FINAL ENVIRONMENTAL IMPACT STATEMENT

PROPOSED WATER SUPPLY RESERVOIR
HUNTER LAKE

APPLICANT: CITY OF SPRINGFIELD, ILLINOIS
PERMIT APPLICATION NO. 187020

NOVEMBER 2000

Figure 1.2.1 CWLP Existing and Projected Water Service Area

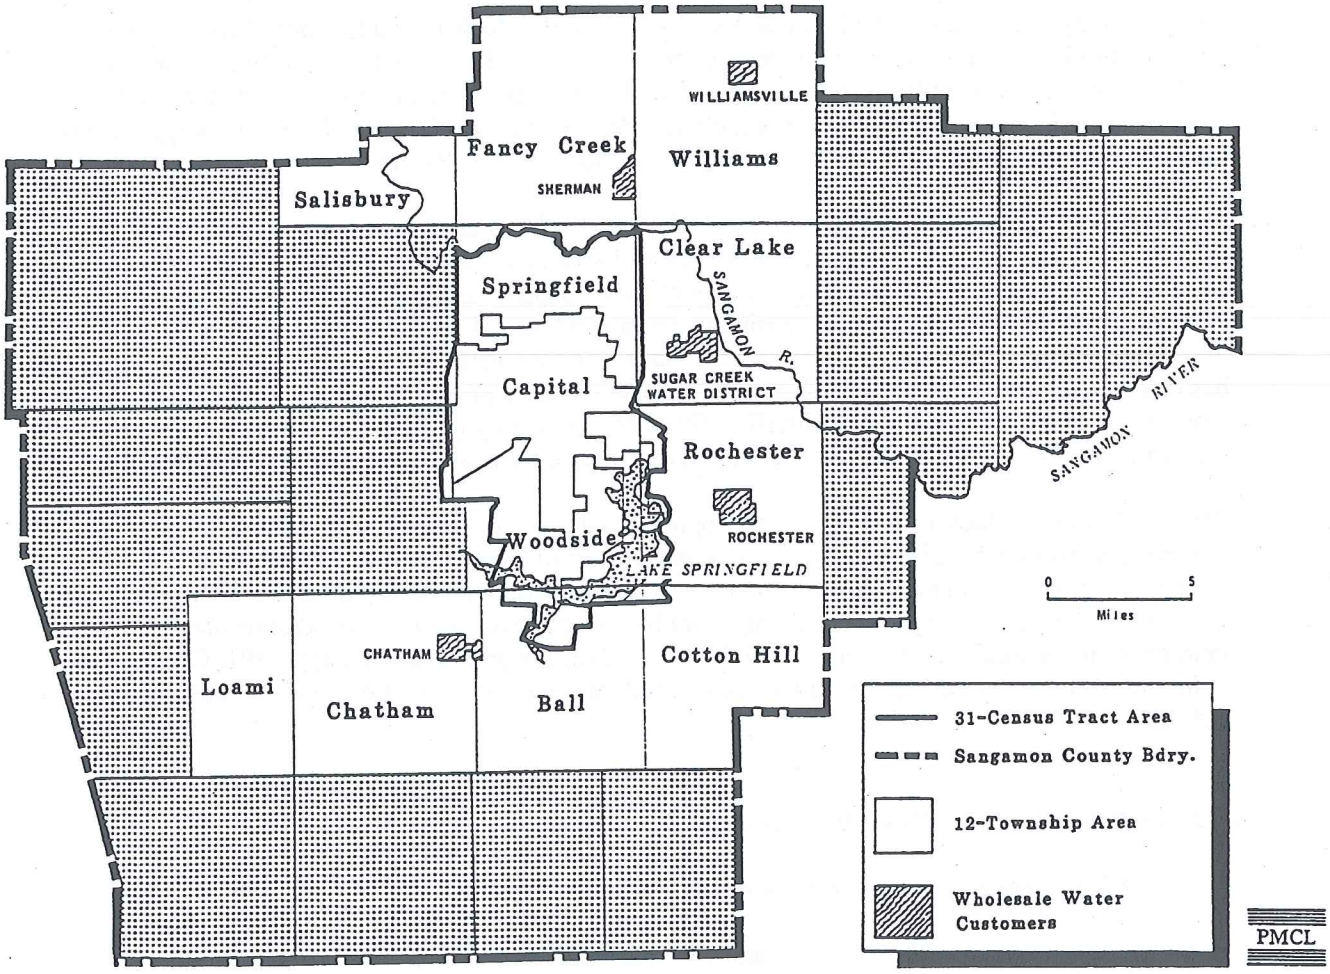
On page 1-5 and in Figure 1.2.1 we wish to bring to your attention that Salisbury township residents located west of the Sangamon river acquire water from the Pleasant Plains Water District, the Curran-Gardner Water District, or private wells - not from Springfield. Both water supply systems are wells in the Sangamon River acquifer downstream from Springfield. Water demand growth in this area will not impact Springfield's supply. 1

Figure 1.2.3.1

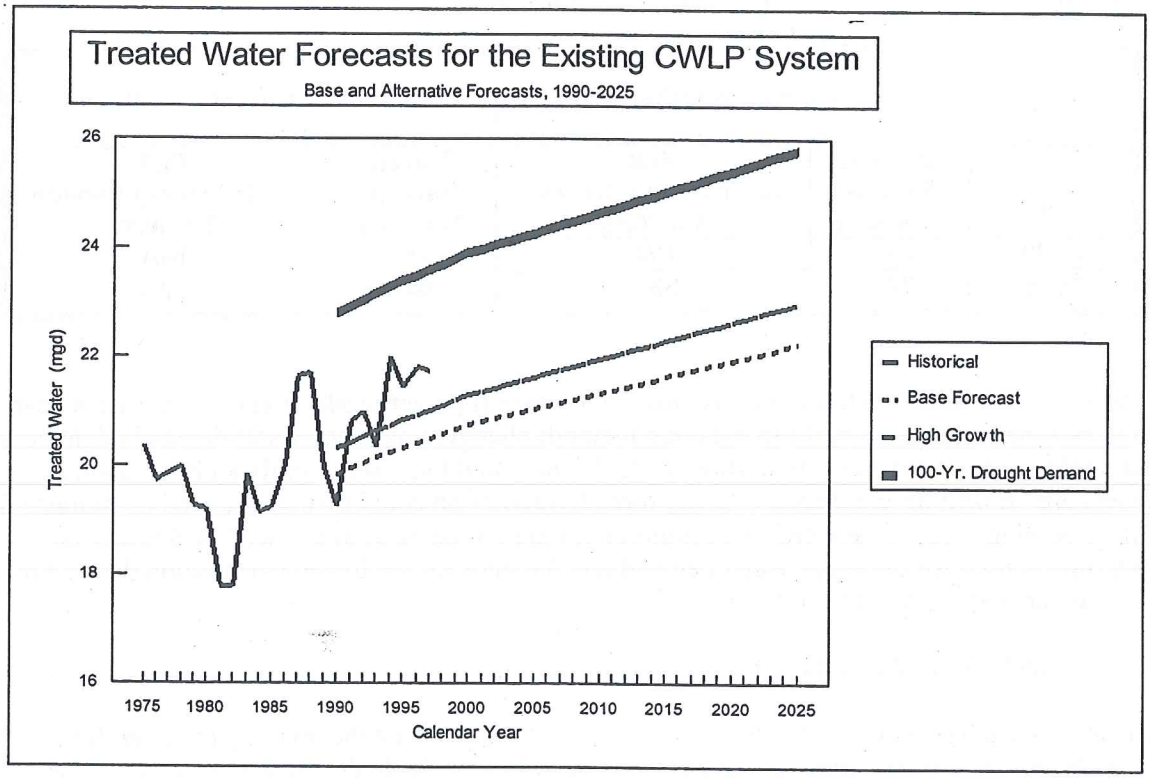
The Effectiveness (mgd) values displayed in Table 2.2.7.2 are not credible. According to figure 1.2.3.1, indoor water use, which is essential water use, currently amounts to about 20 mgd. With the phase in of the January 1, 1994 national water appliance standards, USEPA in its WCPG suggests a 31 percent per capita per day reduction in indoor water use is probable. This 5

4. Page 1-6, Figure 1.2.3.1. Should the base year be listed as 1999 rather than 1990? 4

2. Base treated water demand forecasts shown in Table 1.2.3.1 and Figure 1.2.3.1 of the DEIS were adjusted to incorporate projected water savings of conservation measures already enacted by the City of Springfield (Measures A and H listed in Section 2.2.7 of the DEIS). While Measure A may be considered a voluntary program, Measure H (Water-Conserving Fixture Ordinance) was enacted by the City in 1990. Water savings projections for these and other conservation measures (all described in Section 2.2.7 of the DEIS) were based on reduction factors and coverage estimates developed for the Springfield area. Based on U.S. Census Bureau population projections of 138,080 for 2000 and 154,914 for 2025, future estimates of treated water demand as shown in Table 1.2.3.1 of the DEIS reflect a projected per capita decrease of approximately 4% over the 25-year period.

5. The values presented in Table 1.2.3.1 and Figure 1.2.3.1 represent total treated water demand, which includes both indoor and outdoor water use for residential, commercial, industrial, unclassified, and wholesale sectors. The breakdown of use projections for each of these sectors is shown in a new Table 1.2.3.1 in the FEIS. The blanket application of a 31% reduction in use of indoor residential water fixtures and appliances in future projections of total treated water demand fails to consider other determining factors such as coverage and percentage of unrestricted water use, as noted in the response to comment #2 above.

26. Water use by golf courses such as the two located on Lake Springfield is included in the commercial/institutional sector displayed in the new Figure 1.2.3.1 in the FEIS.
